## KEWAUNEE UNIT NO. 1 COOLDOWN LIMITATION CURVES

APPLICABLE FOR PERIODS UP TO 33<sup>(1)</sup> EFFECTIVE FULL-POWER YEARS

Figure 1 - Current KNPP RPV Cooldown P-T Limit Curves Through 28 EFPY

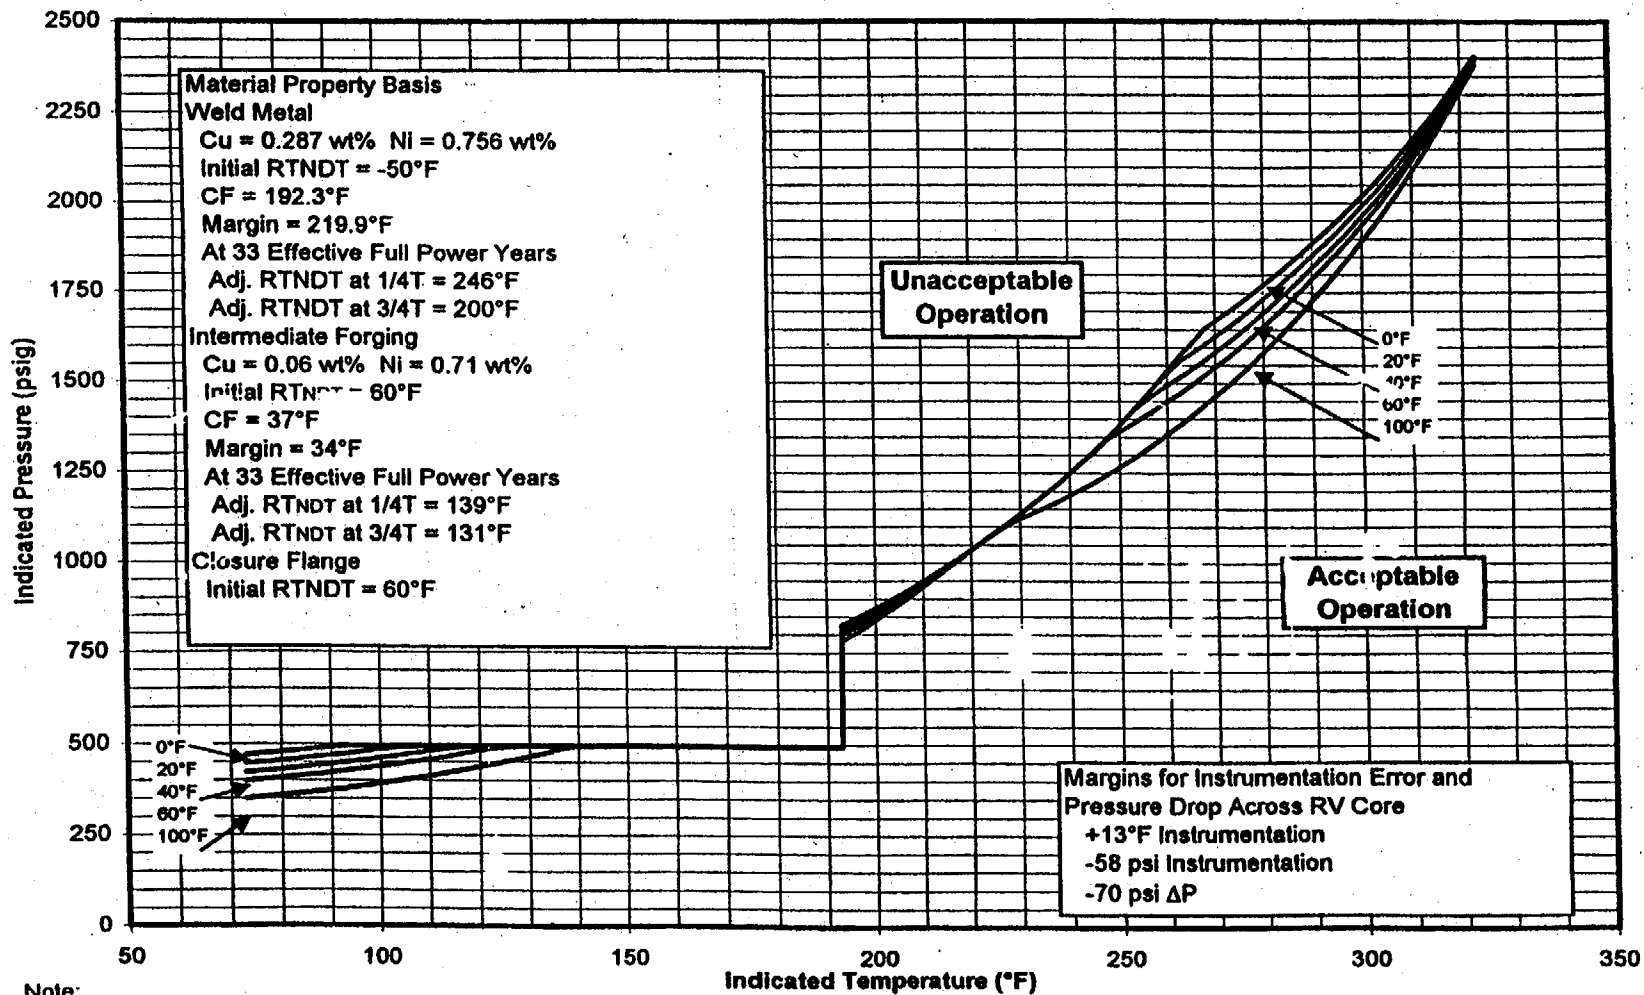
<sup>(1)</sup> Although the curves were developed for 33 EFPY, they are limited to 28 EFPY (corresponding to the end of cycle 28) by WPSC Letter NRC-99-017.

Figure 2 - Proposed KNPP RPV Cooldown P-T Limit Curves Through 33 EFPY
